**PLANNED UNIT DEVELOPMENT &  
SIDEWALK WAIVER REQUEST  
STAFF REPORT**

**Date: December 18, 2014**

<b><u>NAME</u></b>	R&R Group Holdings, LLC / Ivan Blackmon
<b><u>LOCATION</u></b>	7765 Airport Boulevard and 425 Schillinger Road South (Southeast corner of Airport Boulevard and Schillinger Road South, extending to the North side of Thomas Road)
<b><u>CITY COUNCIL DISTRICT</u></b>	District 6
<b><u>PRESENT ZONING</u></b>	B-3, Community Business District
<b><u>AREA OF PROPERTY</u></b>	7 Lots / 23.2 ± Acres
<b><u>CONTEMPLATED USE</u></b>	Planned Unit Development to amend a previously approved Planned Unit Development to allow shared access and parking across multiple lots and Multiple buildings on a single building site, and Sidewalk Waiver to waive construction of a sidewalk along Schillinger Road South.
<b><u>TIME SCHEDULE FOR DEVELOPMENT</u></b>	Immediate
<b><u>ENGINEERING COMMENTS</u></b>

# DETAIL SITE PLAN

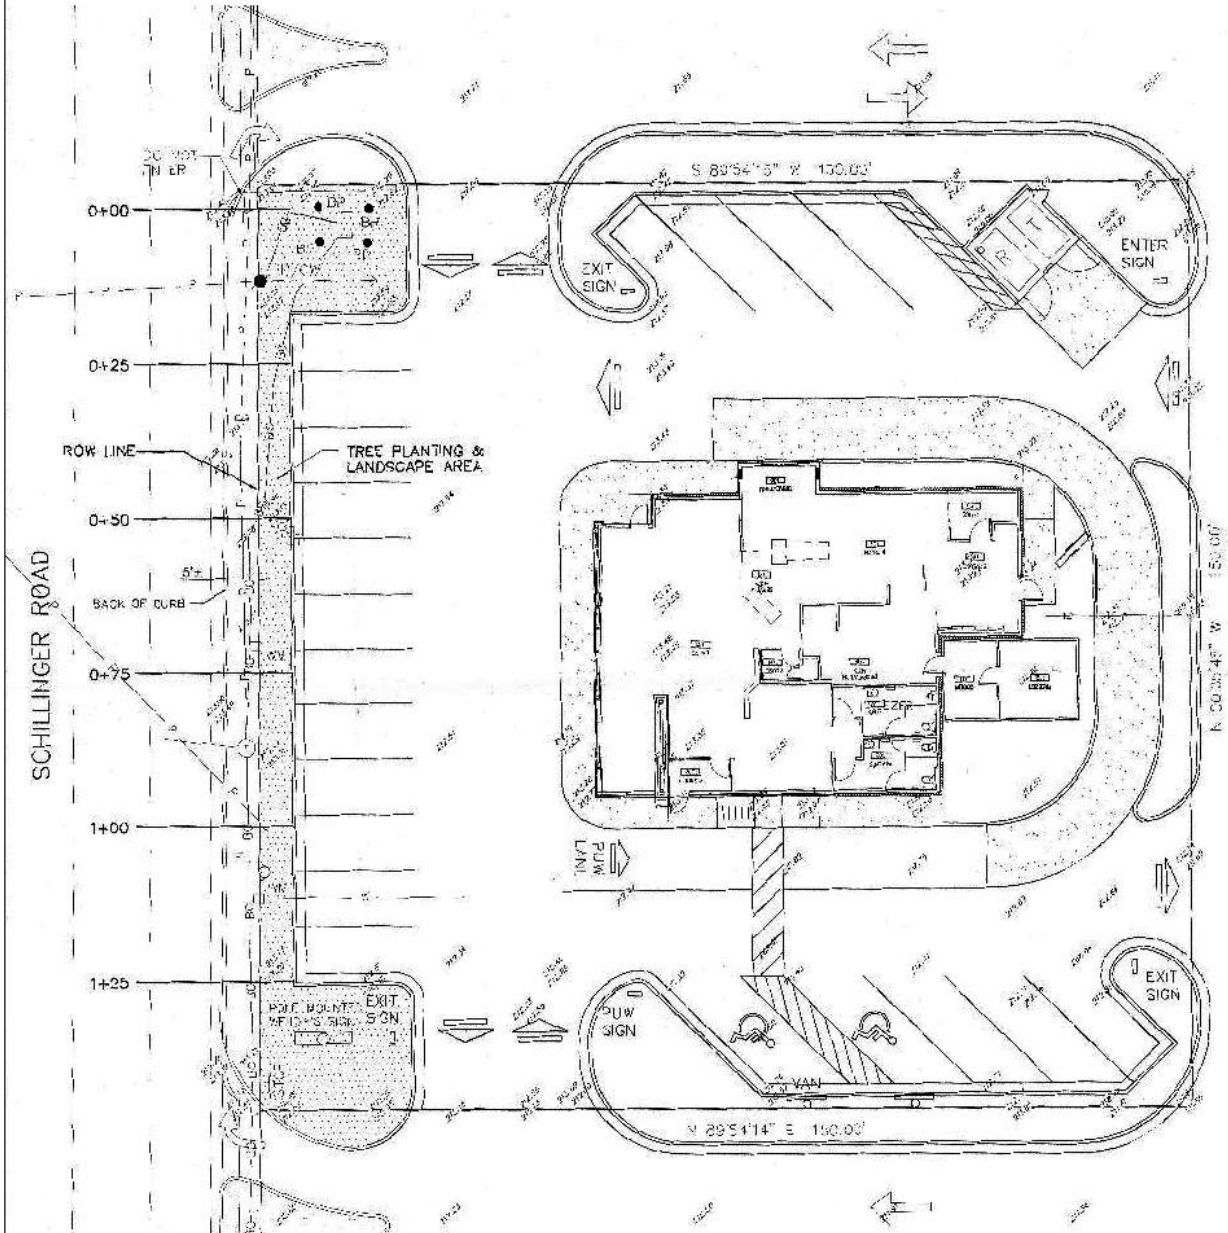
The existing restaurant has a parking ratio deficit, and the proposed restaurant will also have a parking ratio deficit. The redeveloped site will provide 21 parking spaces on-site, however, the restaurant requires 35 parking spaces. Information submitted with the application shows that the entire shopping center (including the new restaurant) has a tenant mix that requires 1,085 parking spaces, and that 1,185 parking spaces will be provided. It should be noted that a large billboard exists on the Wendy's site, and is not shown on the new site plan: the location of the billboard, if it remains, will eliminate one or more proposed parking spaces, thus the site plan should be revised to show the billboard, if it will remain.

The Wendy's site would typically be required to provide 5 frontage trees and 2 parking area trees, with a total landscape area of 2,700 square feet. The two existing front landscape areas large enough for frontage trees appear to be encumbered by an existing single-tenant free-standing sign and ground based electrical equipment, thus it is recommended that two front parking spaces be removed and replaced with two landscape areas that include one frontage tree in each landscape area, with the size and species to match what has been provided elsewhere along the Westwood Plaza frontage (6 inch caliper *Quercus Phellos*): each frontage tree should be separated by a minimum of four parking spaces. The site plan should also be revised to provide two parking area trees, matching the size and species being used elsewhere within Westwood Plaza.

New dumpsters with enclosures are depicted on the site plan. All new dumpsters must be placed in compliance with Section 64-4.D.9. of the Zoning Ordinance, and connected to sanitary sewer.

- 3) Revision of the site plan to depict the existing billboard structure on the Wendy's site, if it is to remain, and to remove any parking spaces that may be encumbered by the billboard structure;

- 1) Revision of the site plan to depict two frontage trees on the Wendy's site, in lieu of two front parking spaces, with the planting areas separated by at least 4 parking spaces, and the frontage trees to match in size and species the other Westwood Plaza frontage trees along Schillinger Road;
- 2) Revision of the site plan to depict two parking trees on the Wendy's site to match the size and species of parking trees planted elsewhere on the Westwood Plaza site;

- 5) Any new dumpsters on the Wendy's site to be placed in compliance with Section 64-4.D.9. of the Zoning Ordinance;
- 6) The remainder of the Westwood Plaza site to comply with the conditions of approval from the April 3, 2014 meeting of the Planning Commission;

# DETAIL SITE PLAN

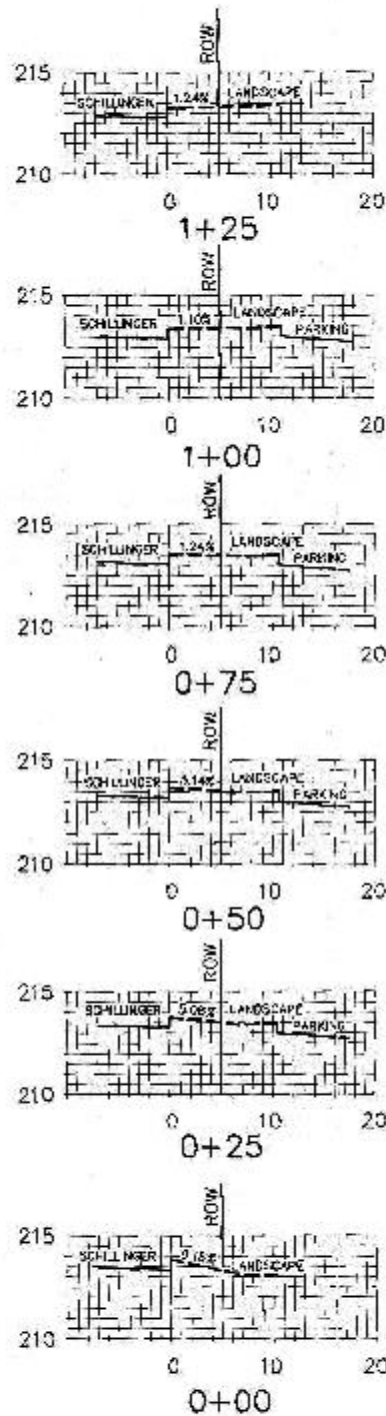
There have been other changes to the overall Westwood Plaza PUD site that are not reflected in the overall site plan provided. The overall PUD site plan should be revised to reflect changes that have occurred at the Chick-fil-A site, the location of any multi-tenant signs, and any other changes to the site. A revised tree and landscape plan for the overall development should also be prepared and submitted for the original Westwood Plaza land disturbance permit.

- 7) Revision of the overall Westwood Plaza site plan to reflect changes that have occurred due to improvements to the Chick-fil-A site, the relocation of multi-tenant pylon signs, etc., with revised site plans submitted to Permitting and Planning;

- 8) Revision of the overall Westwood Plaza tree and landscape plan to reflect changes due to the Wendy's site and other site modifications, with revised site plans submitted to Permitting;
